Access Compliance Report

Public Rights-of-Way

(Curb Ramps)

Intersection ID: 24302	Main Street: PRESCOTT_POND_LN	Cross Street: RATHLIN_CT	Location:	N
ADA ID: ADE4607A4894	Ramp Type: PerpDiag	Initial Pass/Fail: Fail	Overall Compliance: No	Severity Score: 22.5
Codes/Mitigation Info/Possible Solution		Field Measurements/Component Compliance

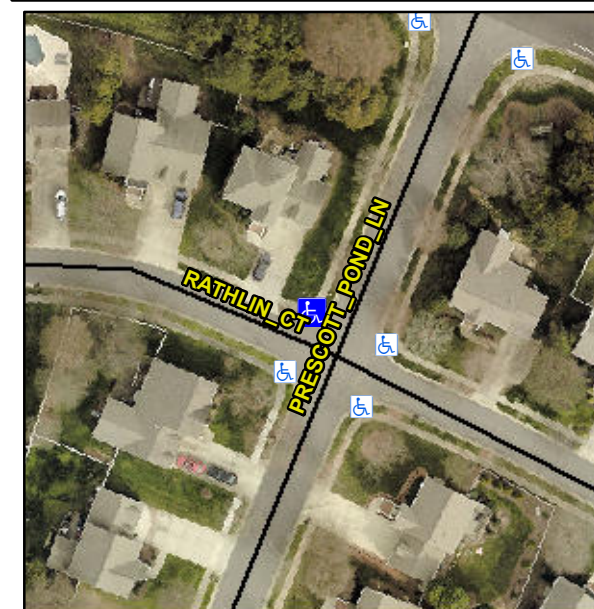
Not Found, R304.5.1, R304.2.2, R304.5.3

Compliance	Description	Data	Compliance	Description	Data
N/A	Ramp Length (in)	46.0	No	Ramp Slope (%)	8.8
No	Ramp Width (in)	47.0	No	Ramp XSlope (%)	2.7
N/A	Flare Type LT	N/A	N/A	Flare Type RT	N/A
N/A	Flare Slope LT (%)	N/A	N/A	Flare Slope RT (%)	N/A
N/A	Flare Traversable LT?	N/A	N/A	Flare Traversable RT?	N/A
N/A	Landing Length (in)	N/A	N/A	DWS Provided?	N/A
N/A	Landing Width (in)	N/A	N/A	DWS Contrast?	N/A
N/A	Landing Slope (%)	N/A	N/A	DWS Length (in)	N/A
N/A	Landing X Slope (%)	N/A	N/A	DWS Full Width?	N/A
N/A	Landing Curb? (Y/N)	N/A	N/A	DWS Offset (in)	N/A
N/A	Shared Landing?	N/A			
N/A	Gutter Ponding?	N/A	N/A	Gutter Slope (%)	N/A
N/A	Gutter Lip Ht (in)	N/A	N/A	Gutter X Slope (%)	N/A
N/A	Painted X Walk1?	No	N/A	Painted X Walk2?	No
	X Walk 1 Direction	To SW		X Walk 2 Direction	To SE
N/A	X Walk 1 Width (in)	N/A	N/A	X Walk 2 Width (in)	N/A
	X Walk 1 Slope (%)	3.2		X Walk 2 Slope (%)	7.6
	X Walk 1 X Slope (%)	3.1		X Walk 2 X Slope (%)	1.5

N/A	Ramp inside XWalk1?	N/A	N/A	Ramp inside XWalk2?	N/A
	Road Slope (%)	2.0	N/A	Clear Space?	N/A
	Road X Slope (%)	5.3	N/A	Clear Space to XWalk (in)	N/A
N/A	Any Obstructions?	N/A	N/A	Storm Grate/Utility Hazard?	N/A
	Obstruction Type			Storm Grate/Utility Type	
		N/A			N/A
			Yes	Surface Condition? (G/P)	Good

Remove & Replace Curb Ramp With Two New Directional Ramps or Equivalent.
